CITY OF LACONIA
REGULAR PLANNING BOARD MEETING
Tuesday, January 6, 2026 - 6:30 PM
City Hall - Armand A. Bolduc City Council Chamber

6.1. PB2026-021; 604 Endicott St N (128-252-3.1)

Applicant proposes to amend their previous site plan approval to increase the size and capacity of the stormwater detention pond.

Re: 604 Endicott St N, Laconia Site Plan

Figure 1: Route 3 Flow

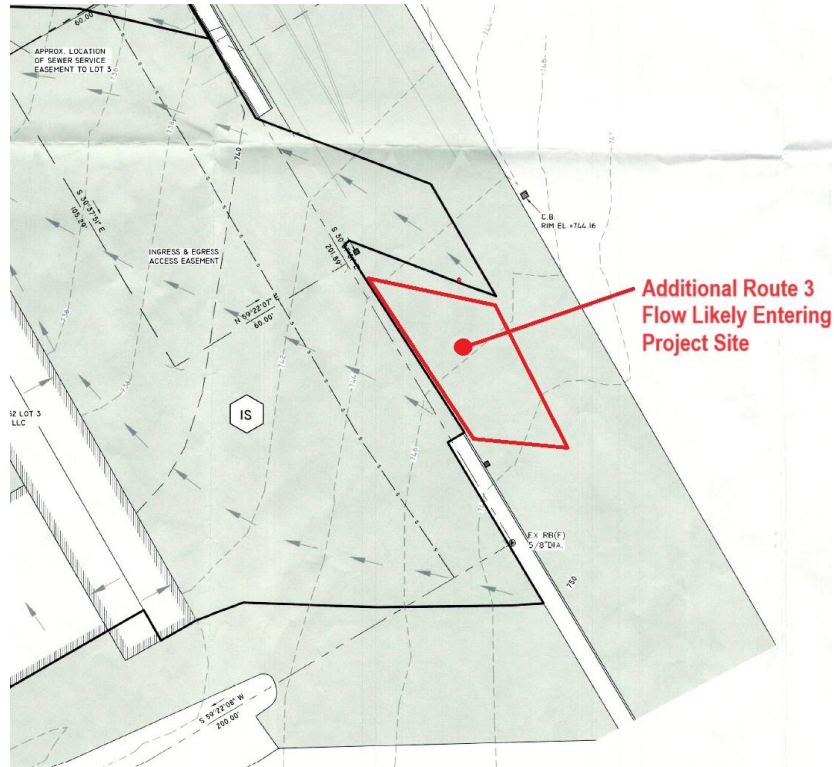
1. As stated previously, the hydrologic model appears to underestimate the area of Route 3 flowing onto 604 Endicott St N. No additional area was added to the revised stormwater calculations to account for this flow from Route 3. The existing and proposed flows onto 554 Endicott St N are likely slightly underestimated by the model. See Figure 1 and Figure 2 on the following page:

Figure 3: Rear Gravel (Existing Conditions Plan)

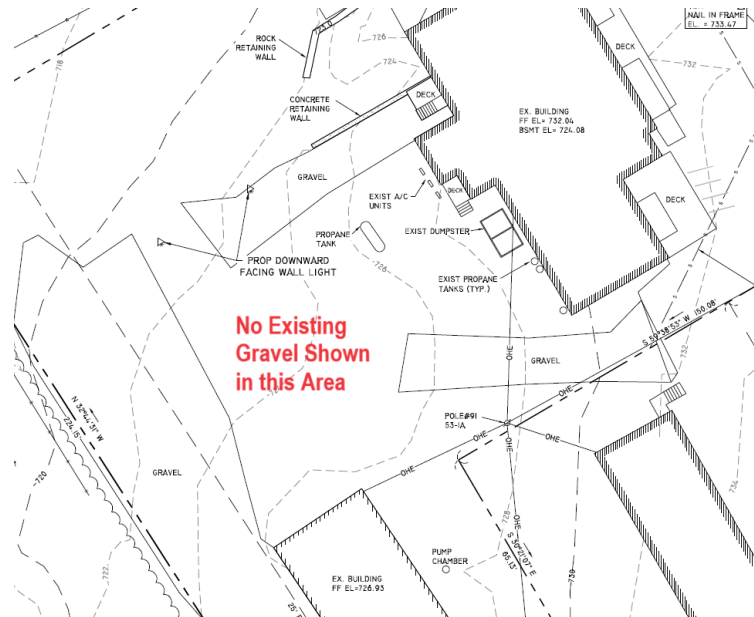
2. As stated previously, the Pre-Condition map depicts approximately 4,000 sq ft of existing gravel area that is not depicted on the Existing Conditions plan. This area was not added to the pre-development drainage model. If this gravel area does not exist then the model likely calculates the existing flows to be higher than they actually are. This, in turn, may result in proposed flows that are higher than the actual existing flows.

Figure 1: Route 3 Flow

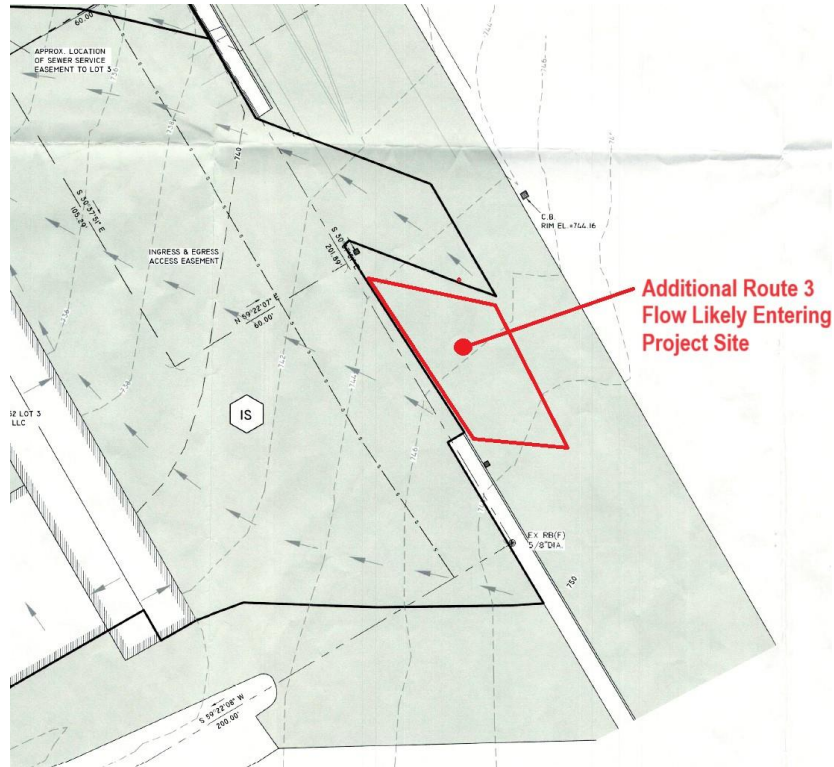
1. As stated previously, the hydrologic model appears to underestimate the area of Route 3 flowing onto 604 Endicott St N. No additional area was added to the revised stormwater calculations to account for this flow from Route 3. The existing and proposed flows onto 554 Endicott St N are likely slightly underestimated by the model. See Figure 1 and Figure 2 on the following page:

Figure 3: Rear Gravel (Existing Conditions Plan)

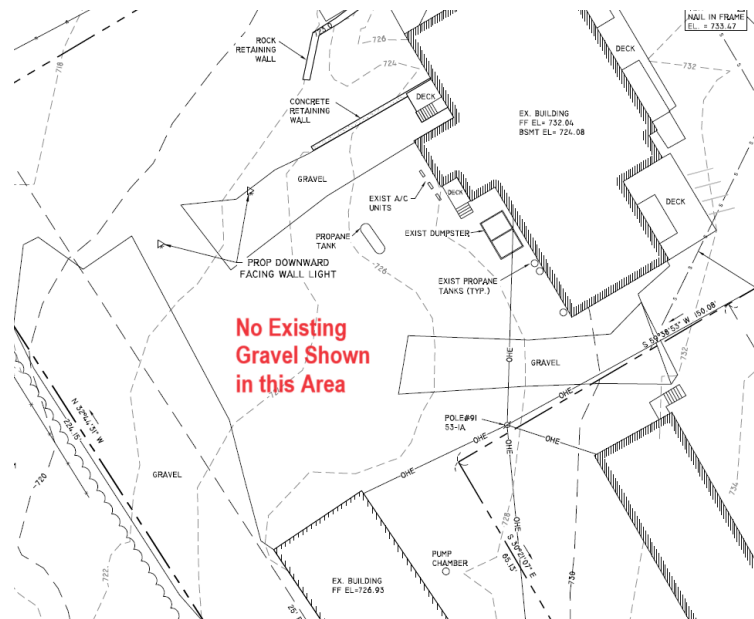
2. As stated previously, the Pre-Condition map depicts approximately 4,000 sq ft of existing gravel area that is not depicted on the Existing Conditions plan. This area was not added to the pre-development drainage model. If this gravel area does not exist then the model likely calculates the existing flows to be higher than they actually are. This, in turn, may result in proposed flows that are higher than the actual existing flows.
